2.206 - Watts Bar Nuclear Plant - Reactor Coolant  
System Stainless Steel Cladding Defects Demand for  
Information

May 30, 2003

**SUBJECT: Watts Bar Nuclear Plant – Petition Pursuant to 10 CFR 2.206 – Reactor Coolant System Stainless Steel Cladding Defects Demand for Information**

**Looking into the cold leg piping of reactor coolant loop #2 showing defect in the stainless steel cladding at the approximate one o'clock position.**

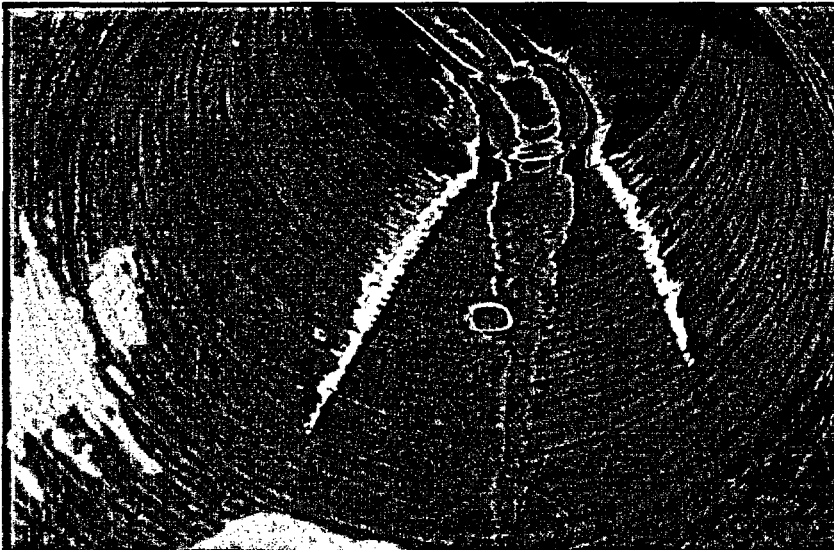
The carbon steel reactor pressure vessel at Watts Bar was coated with stainless steel to provide the corrosion resistance against the borated water used as reactor coolant. But as the photographs on the next two pages clearly illustrate, defects in the stainless steel coating for the cold leg nozzles permit direct and constant exposure of the carbon steel reactor pressure vessel to corrosive borated water.
